# CITY PLANNING COMMISSION

PROPOSAL: The applicant is requesting the necessary entitlements to construct a 4,500 sq. ft. 82 seat, 24 hour fast food restaurant with one drive-up window.

P87-220 APPLC.NO.

PROJECT EVALUATION: Staff has the following comments.

87-720 January Comment FOODMAKER, INC. 6 10,350 S 5 30,026 SP ISSUE DATE: 4/29/87 DRAWN BY: KINTEBOK BLVD. A FRUITRIDGE RD. SITE PLAN Then NO SCALE DEVELOPMENT PLAN

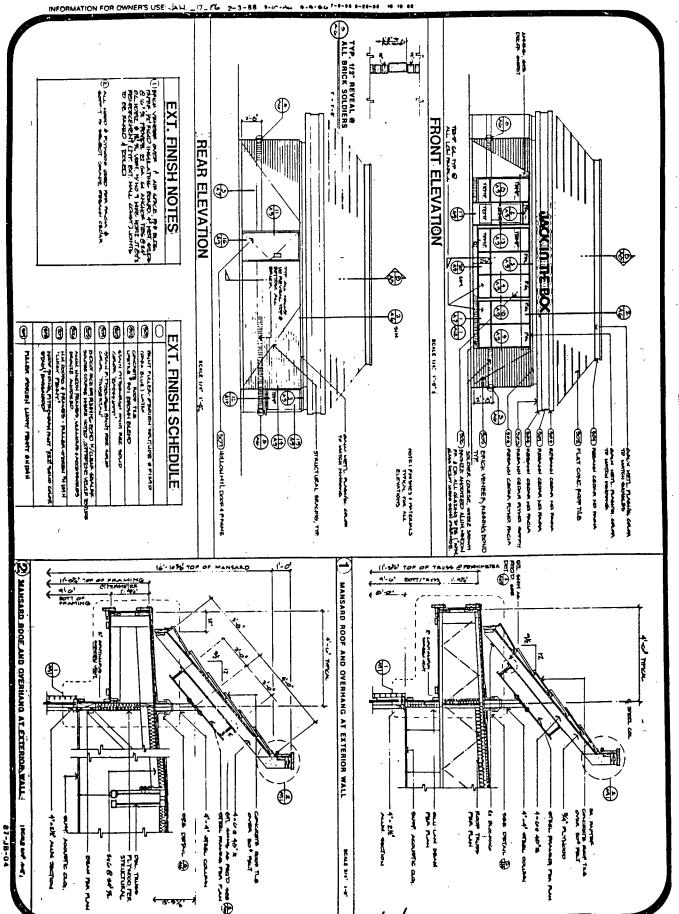
The applicant proposes to provide the required 27 parking spaces on-site. Eight of the required 27 parking spaces will use a portion of the existing shopping center driveway off-site to provide the needed backout and maneuvering area (see site plan). The applicant has agreed to provide either a reciprocal access agreement or lease agreement with the adjacent property owner to allow the use of the adjacent parcel for backout and maneuvering area (see Exhibit C). Staff has no problem with allowing the applicant to use a portion of the adjacent parcel for the required backout and maneuvering area. Staff recommends the applicant provide a copy of a satisfactory lease or reciprocal access agreement to Planning Staff prior to the issuance of a building permit.

Traffic Engineering has reviewed the internal circulation of the proposed site plan. There is adequate room for stacking of autos for the drivethrough window and the overall circulation on the site plan was determined by Traffic Engineering to be satisfactory. Traffic Engineering also has no problem with the variance request to locate backout and maneuvering space off-site.

The applicant proposes to locate a trash enclosure on the project site (see site plan). Staff recommends the trash enclosure be designed per the attached guidelines as shown on Exhibit B.

A reciprocal access easement agreement shall be submitted to the Planning Director for review and approval prior to the issuance of a building permit.

**ELEVATIONS**

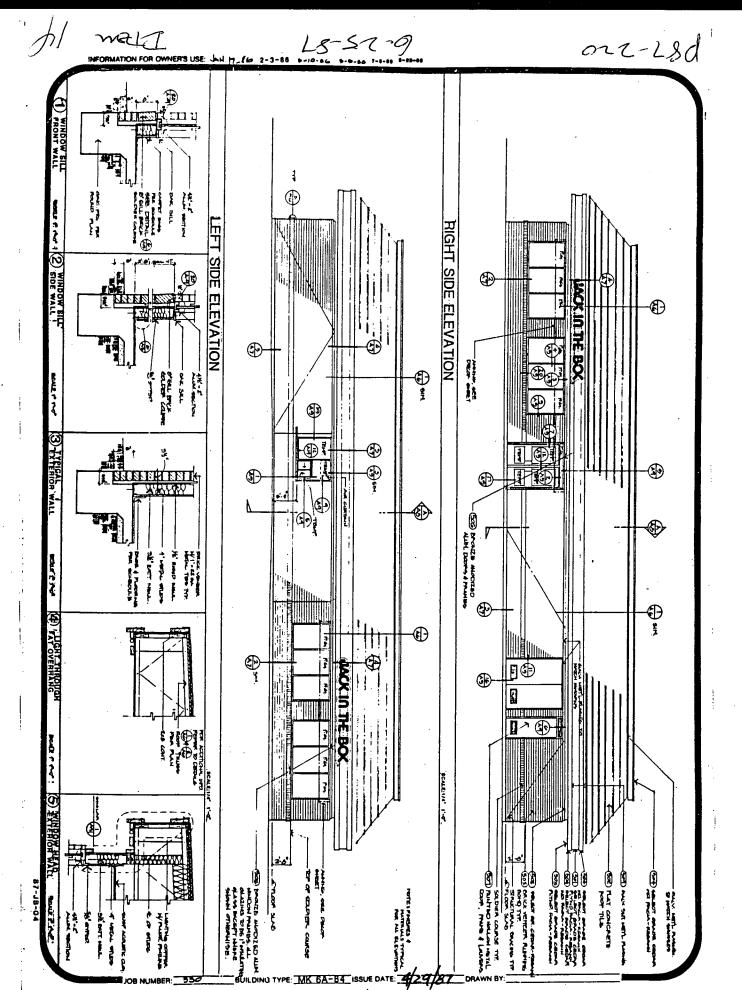
The original elevations submitted were evaluated by Staff in the context of the established architectural style of the existing shopping center located adjacent to the project site. Staff concluded the original elevations needed to be revised to incorporate, to some degree, the parapet walls and metal awnings of the existing shopping center buildings. Staff met with the applicant who has agreed to redesign the proposed elevations incorporating the design concept as shown in Exhibit A. Staff recommends revised building elevations be submitted to the Planning Director for review and approval prior to the issuance of a building permit.

1. The proposed building shall be redesigned as per Exhibit A and shall be subject to the review and approval of the Planning Director.
